**CITY OF AUSTIN  
APPLICATION TO BOARD OF ADJUSTMENT  
GENERAL VARIANCE/PARKING VARIANCE**

STREET ADDRESS: 4408 Rivercrest

**Re:** 4408 Rivercrest Drive AP-2014-0123DS Update #2

Re: Environmental Assessment Report, Engineer's Floodway Encroachment Certification and Summary Letter for a Single-Family Boat Dock on Lake Austin at 4408 Rivercrest Drive, Austin Texas

4408 Rivercrest Drive

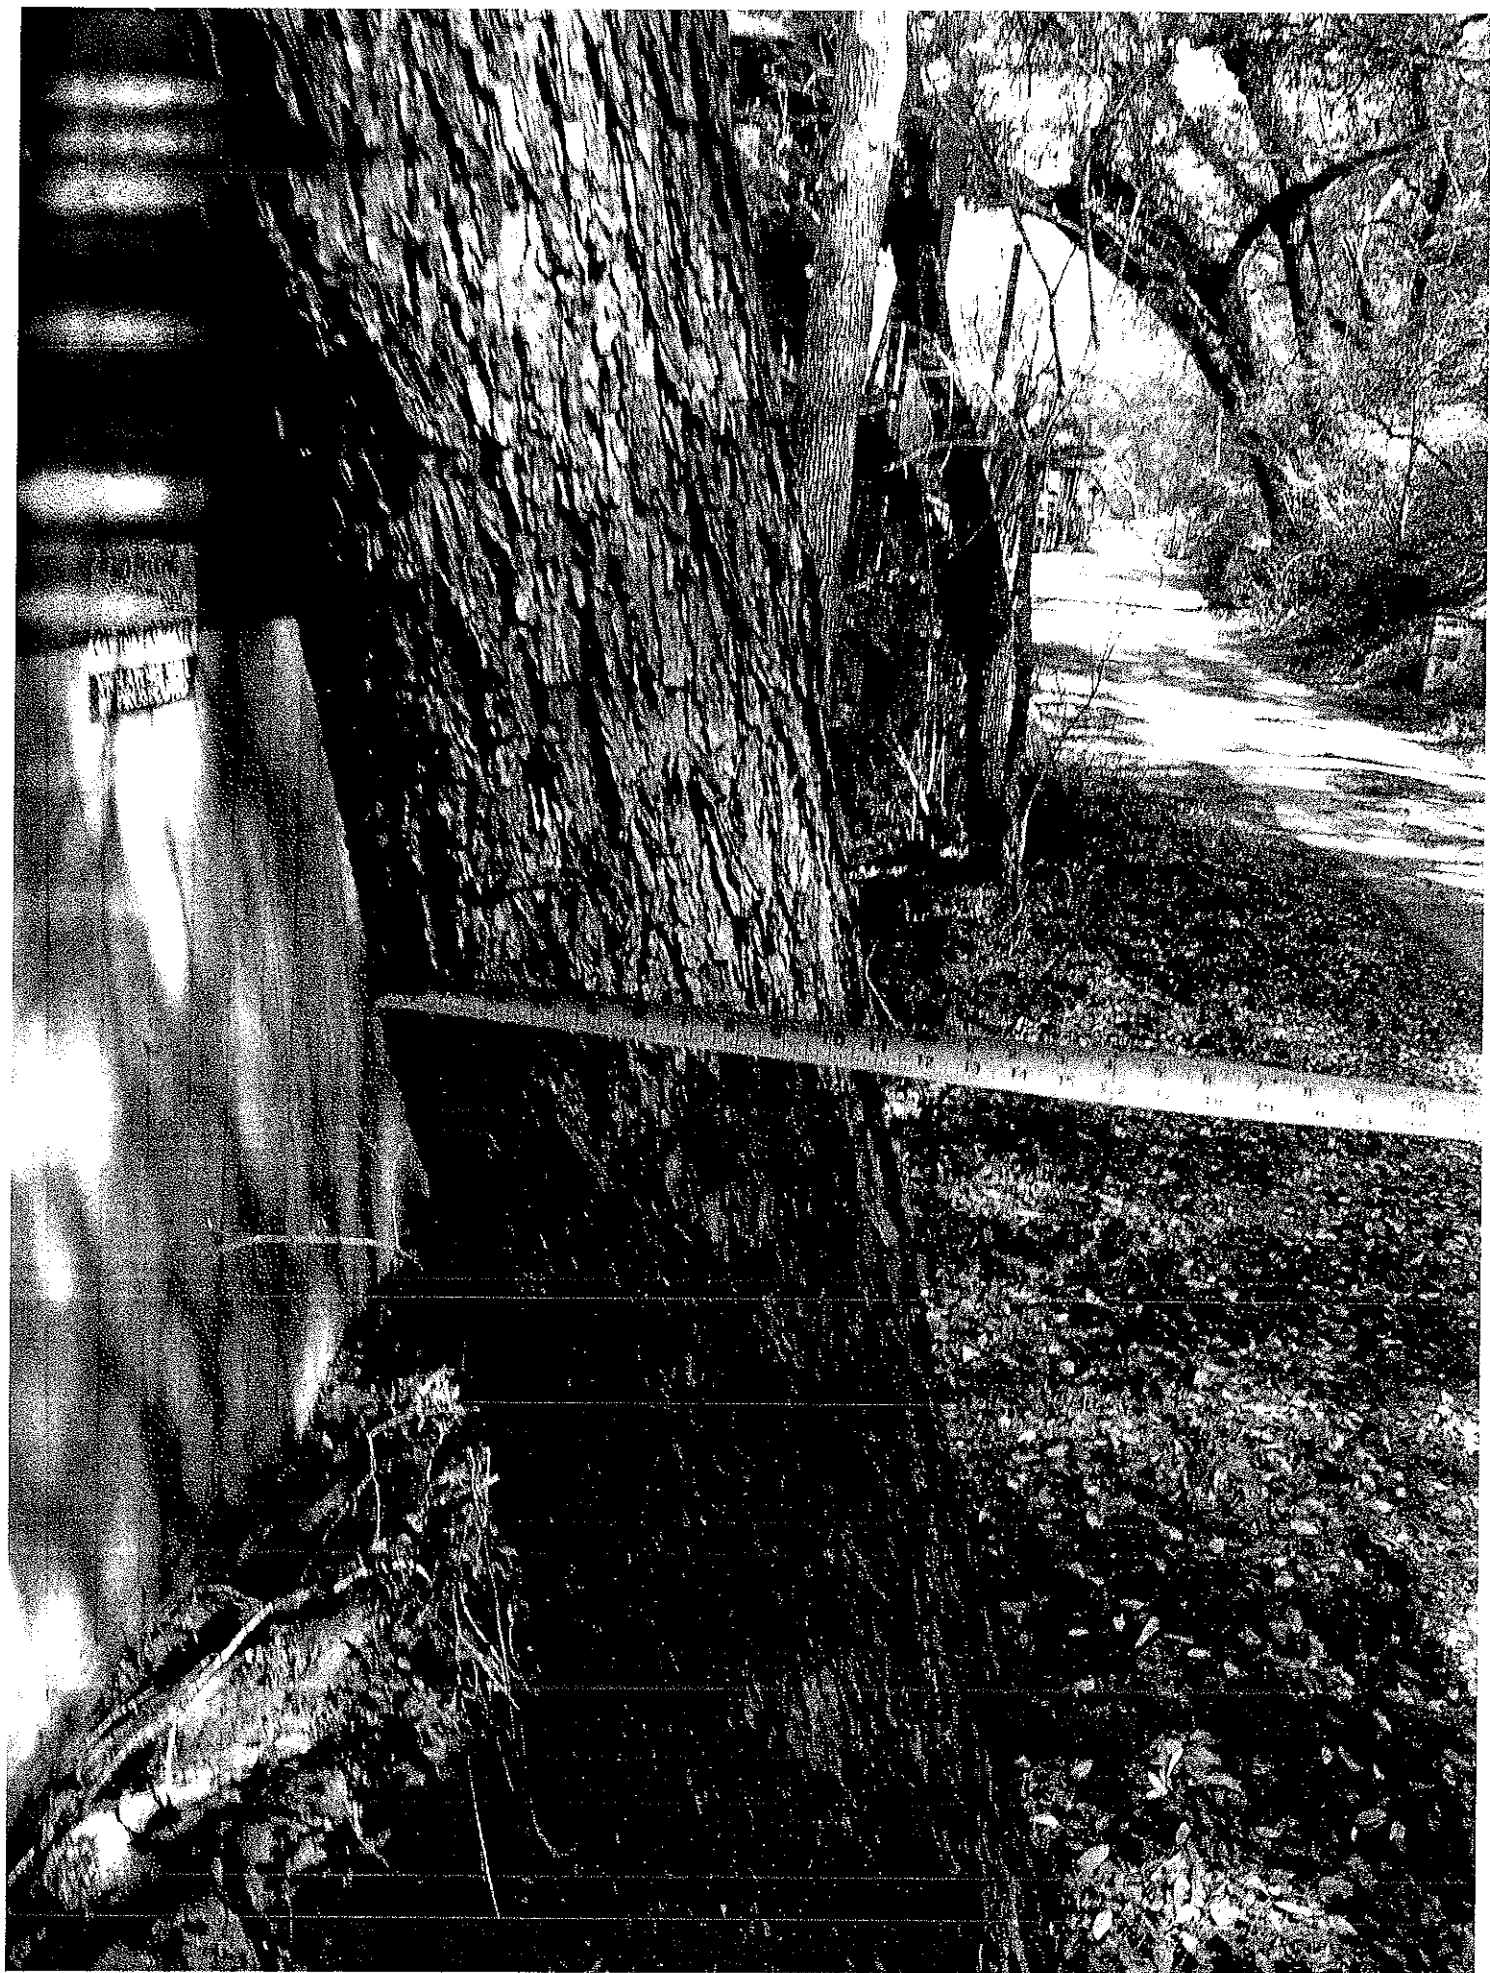
The following remarks are responses to several of the City review comments generated 05/19/14 for the referenced site plan.

SP2,3,6,11&14 The requested changes have been made on the plans.

SP4 No, we don't anticipate all work to be done via barge since there is a PAVED common access easement adjacent to the docks for all the dock in the area. We expect workmen and their tools will arrive via land.

SP 9-10 We understand that PC consideration is required for approval of the width and depth.

EV6 We understand that PC consideration is required for approval of the width and depth.

EV7 We're removing 8" LO since it conflicts with the stair, but leaving the 10" LO and 6.5" Pecan to remain along with several other woody plants. The total cross sectional area of the remaining woody plants exceed 70% of the total woody plants within the shoreline setback.
